# Access Compliance Report

## Public Rights-of-Way

### (Pedestrian Signals)

Intersection ID: N/A	Main Street:	Cross Street: N/A	Location: N/A
ADA ID: F252BB7DEDC2	Signal Type: One Push Button-Non APS	Overall Compliance: No	Severity Score: BTN 1: N/A BTN 2: N/A No BTN: N/A
Codes/Mitigation Info/Possible Solution		Field Measurements/Component Compliance

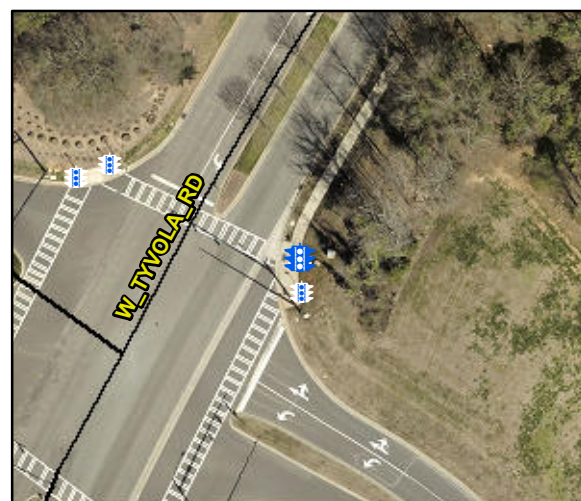
Surveyor Notes: TEXT HT 1/2

PROW/ADA: TMUTCD 4e.08, R410.6, R209.1, R404.7.2

No	B 1 Clear Xing Direction?	NotClearlyMarked	N/A	B 2 Clear Xing Direction?	N/A
	B 1 Crossing Direction	To NW		B 2 Crossing Direction	N/A
Yes	B 1 DistanceTo XWalk (in)	15.0	N/A	B 2 DistanceTo XWalk (in)	N/A
No	B 1 DistanceTo Curb (in)	132.0	N/A	B 2 DistanceTo Curb (in)	N/A
Yes	B 1 Diameter (in)	2.0	N/A	B 2 Diameter (in)	N/A

Possible Solutions: Replace Signal Push Button With APS Button on New Post. Remove & Replace Sign.
